**ADDENDUM NO. 1
July 25, 2022**

**2022 Midfield Ramp Repair – Phase 1
Duluth International Airport (DLH)
Duluth, Minnesota
City of Duluth No. 22-4402
SEH No. DULAI 161944**

**Taxiway A Reconstruction – Phases 2 & 4
Duluth International Airport
Duluth, Minnesota
AIP No. 3-27-0024-074-2022
SP No. A6901-205
SEH No. DULAI 165102 & 167744**

SHEET TITLE
**EARTHWORK
SUMMARY - PHASE 4
& BIO-RETENTION
POND (BASE BID)**

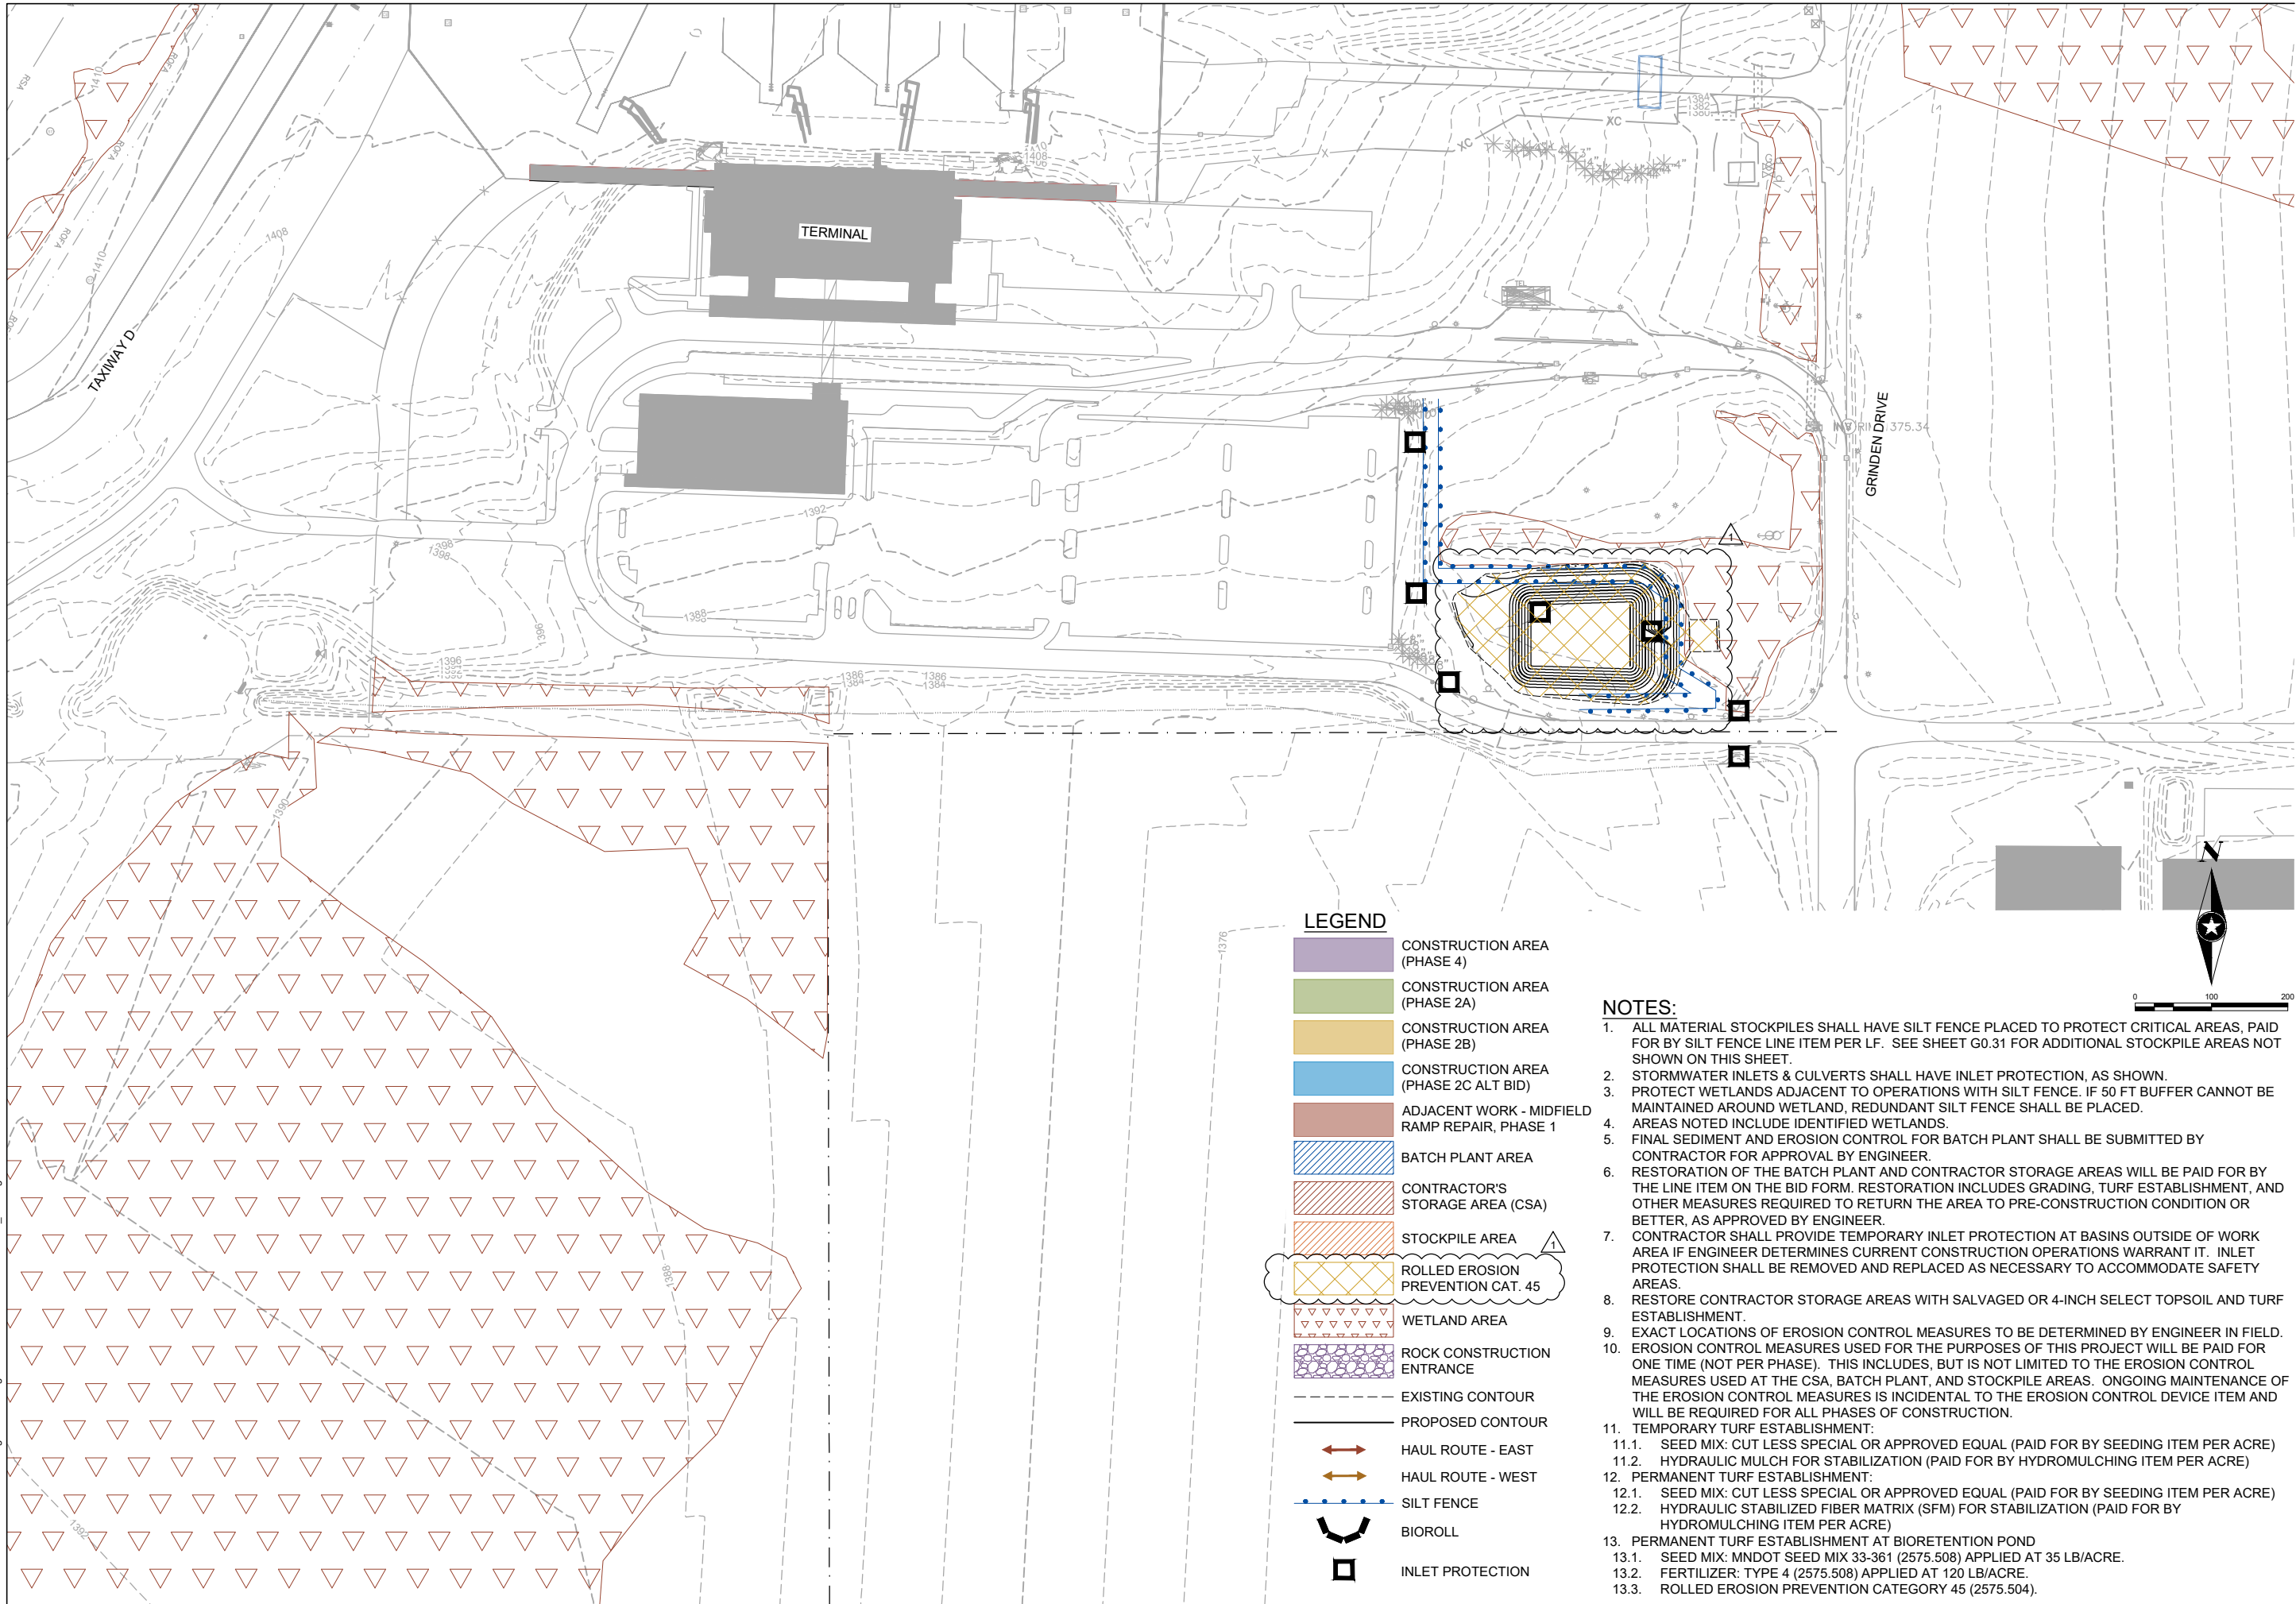
13. Drawing G0.48 Earthwork Summary Phase 4 & Bio-Retention Pond (Base Bid) – Total Excavation Estimated Quantities have been adjusted. Additional excavation added for VSR road.

SHEET
C0.12

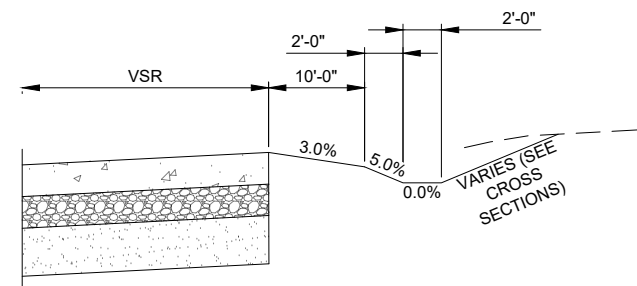
14. Drawing C0.12 Erosion Control Plan – Bio-Retention Pond – An erosion control blanket has been added to the Bio-Retention Pond.
15. Drawing C1.04 Typical Section SRE Apron – Note added to Electrical Ductbank Trench Restoration Detail regarding payment. The typical section for the VSR road has been modified and has increased to a 39-inch depth.

SHEET
C3.04

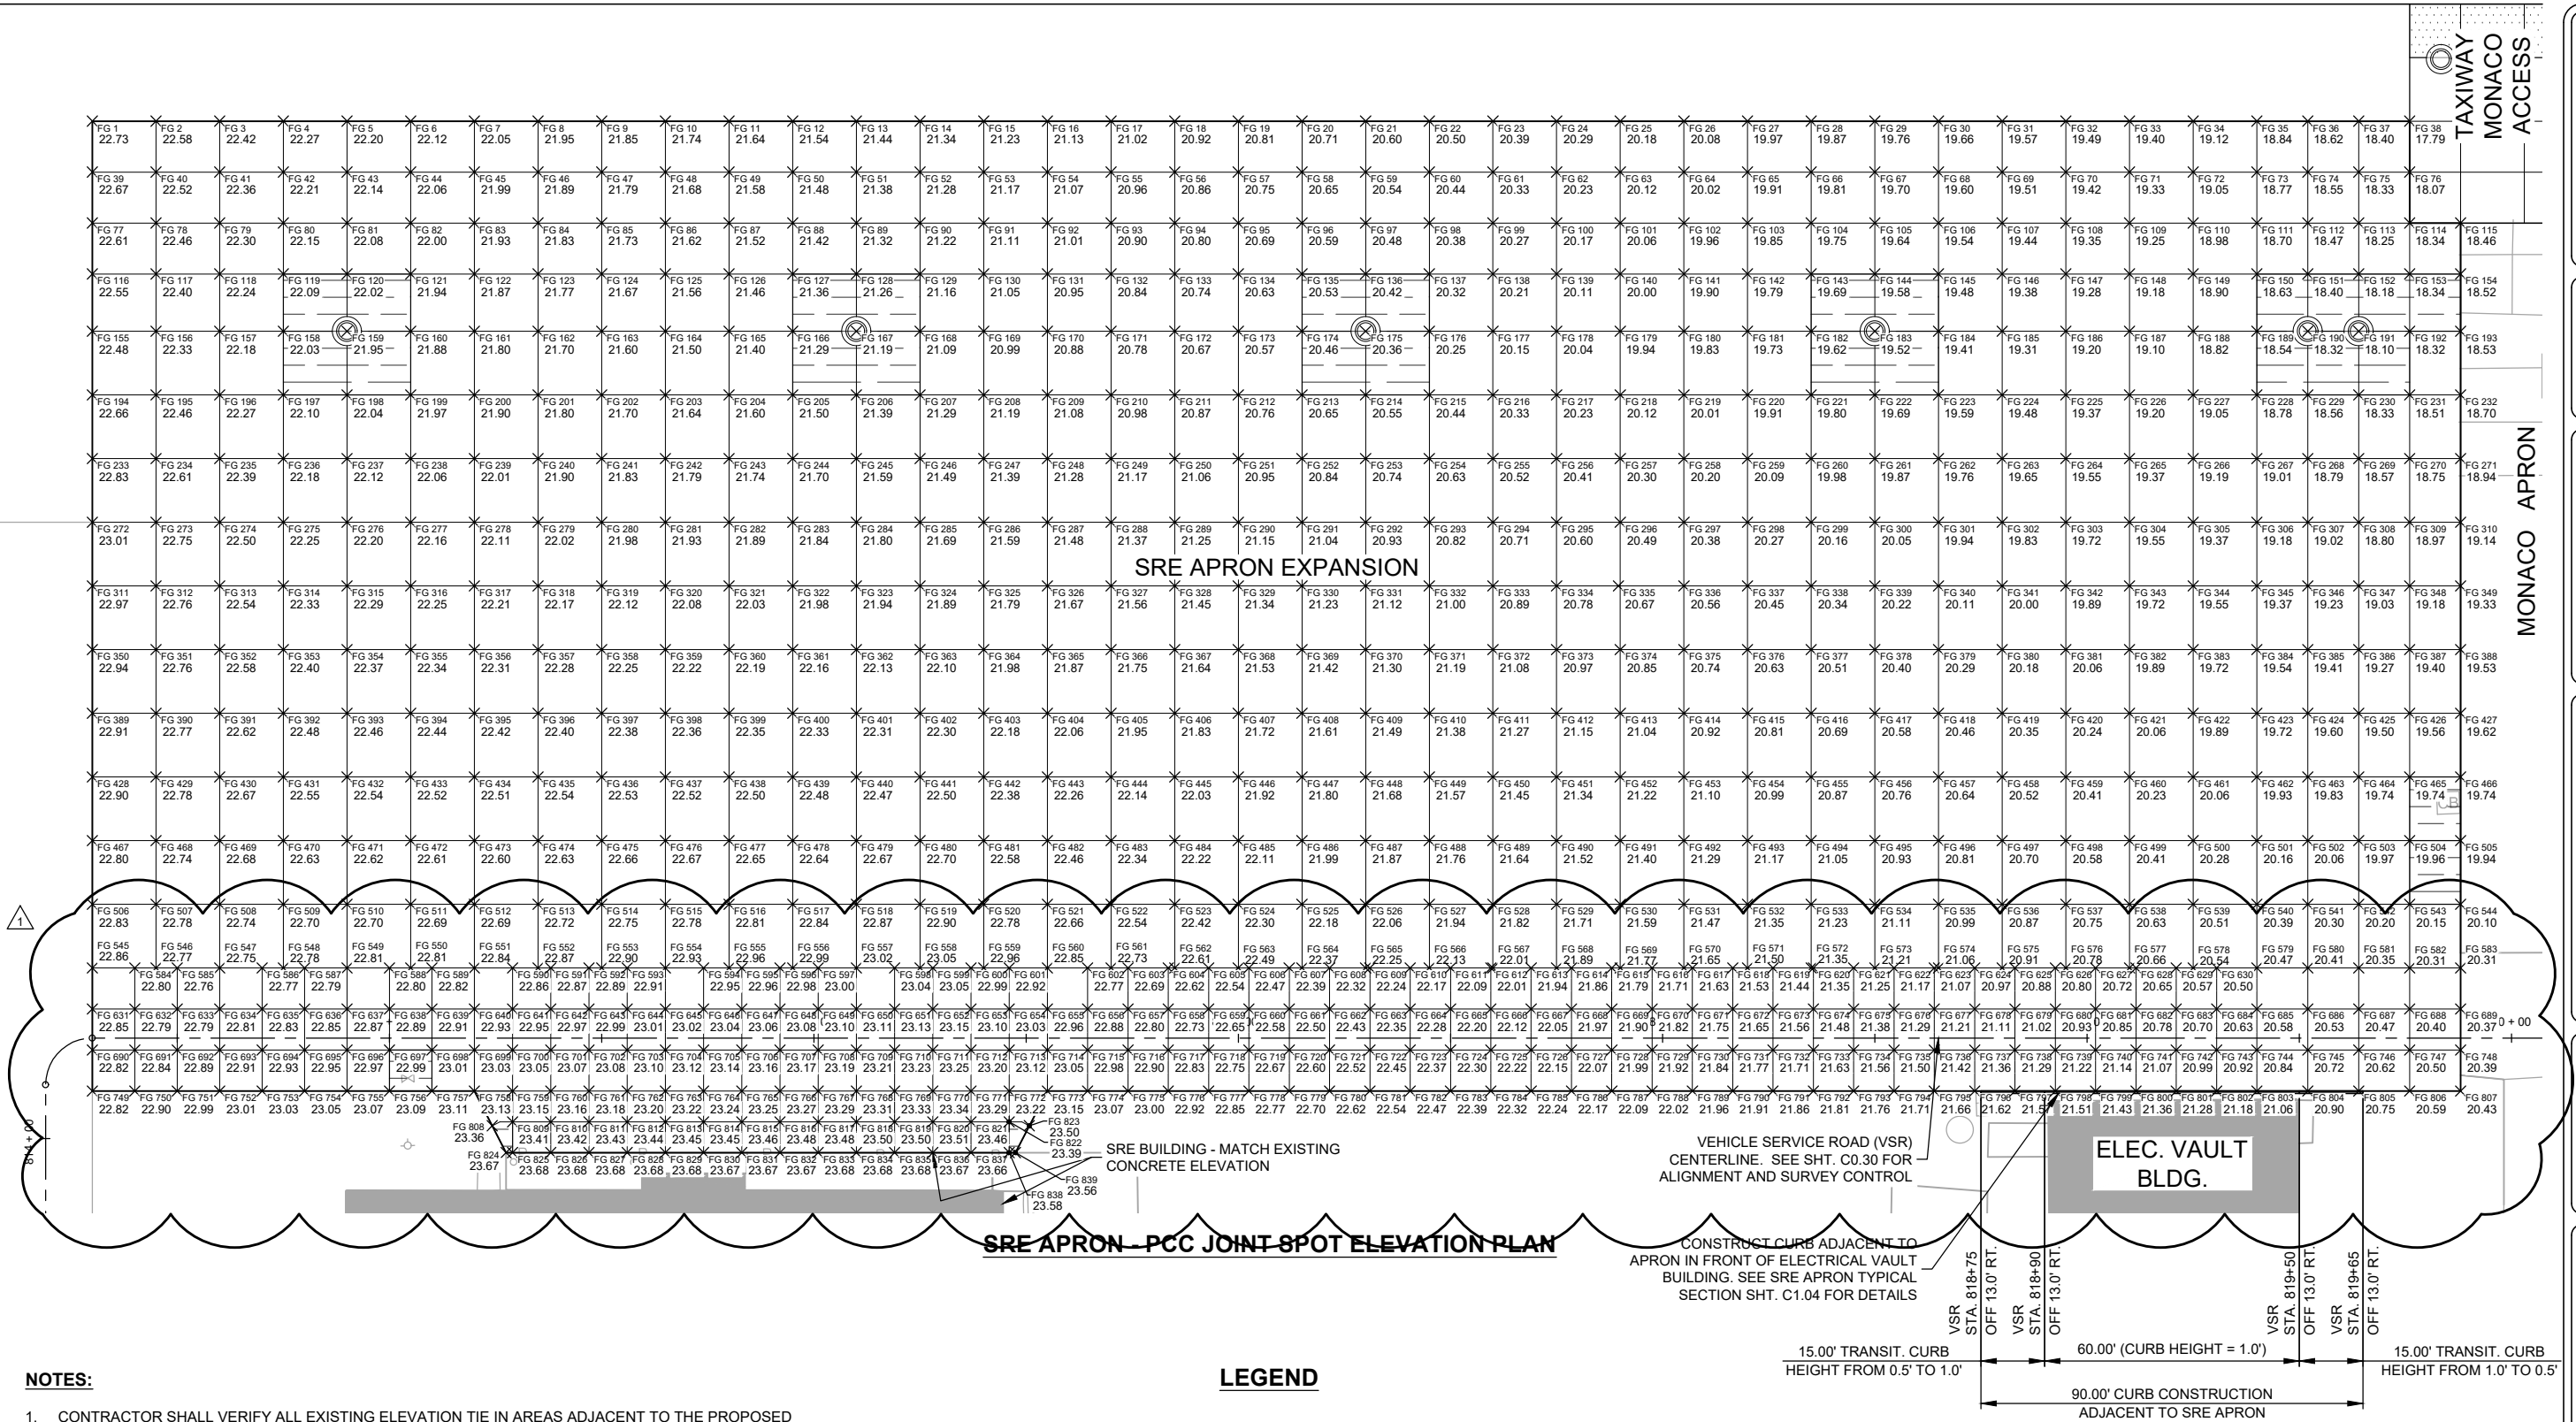
16. Drawing C3.04 PCC Joint Elevation Plan (SRE Apron) – Phase 4 – The jointing plan for the SRE Apron VSR has changed.
17. Drawing C3.07 PCC Joint Elevation Tables (SRE Apron) – Phase 4 – The spot elevation tables for the SRE Apron VSR have changed.
